CONSEIL INTERNATIONAL
DES MONUMENTS ET DES SITES

Report on Mission to Luang Prabang

Professor Edward N. Bromhead

Professor of Geotechnical Engineering, Kingston University

Figure 2. Sketch section of affected slope showing features mentioned in the text.

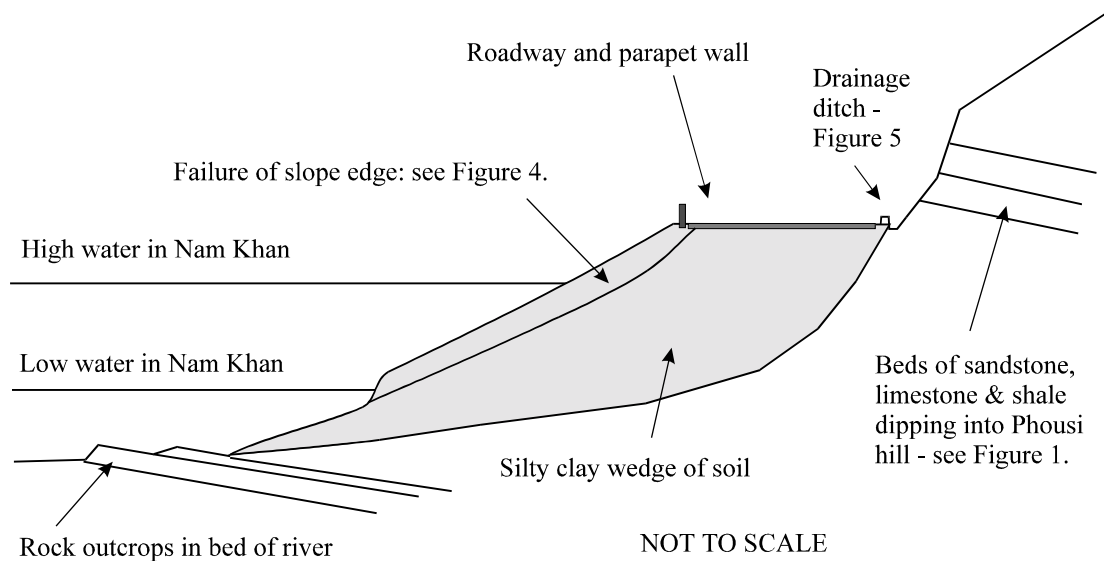
The road and slopes down to the Nam Khan river are not cut into the bedrock. Instead, they are both formed in a wedge of soil. I have sketched this in my Figure 2, which is not to scale. Bedrock outcrops in the floor of the Nam Khan river, and in places at the foot of the slope. It is better visible when the Nam Khan river level is lower than at the time of my visit, but even at this time, turbulence in the river marks the position of prominent outcrops.

The soil failure that prompted the design of river erosion control and slope stabilisation works is a small-scale slip of the slope formed in this wedge of soil. It is significant only in that it threatens a major access to the town: it does not threaten and significant parts of the historic town centre or its buildings, except perhaps on a geological time scale measured in thousands of years.

Figure 6. Water flows from leaky drains – a speculative illustration of possibilities .

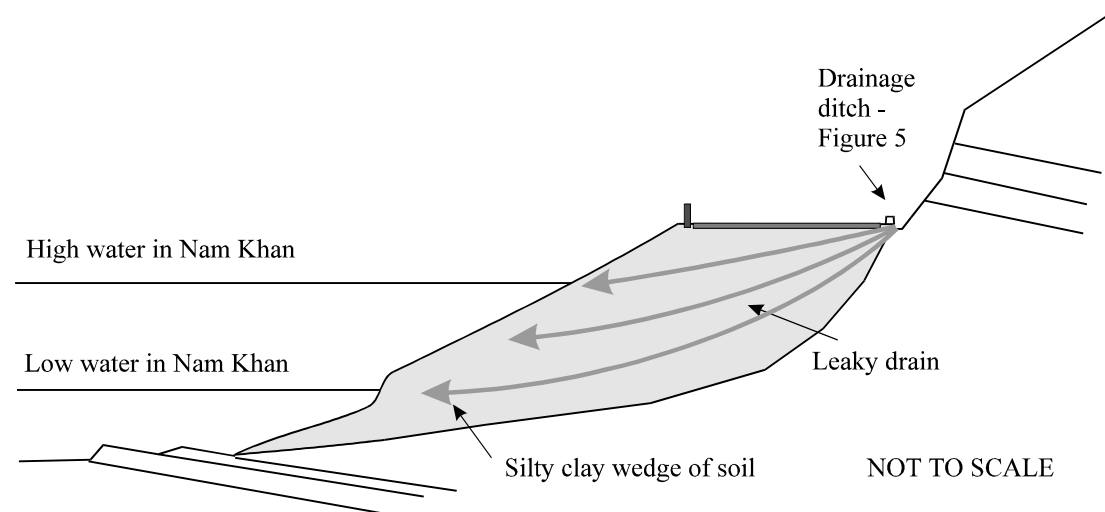
Water running off the Phousi hill is caught in a drainage ditch (Figure 5). These ditches are very widespread in Luang Prabang, and carry not only rainwater, but also waste water. I know of other cases elsewhere in the world where such drainage ditches leak, and feed water into the soils under roads (see sketch Figure 6). The ingress of water from this source can sometimes be serious for soil stability. I have no evidence that this drain at Luang Prabang is a problem, but in the reconstruction, care must be taken to ensure that the drain is not leaky.

Rainwater falling on the road cannot easily enter the ditch, and must find another route to enter the river. I do not believe that the highway drainage system is adequate for maximum rainfall events. Rainwater has clearly poured off the road in the area of the slip failure.
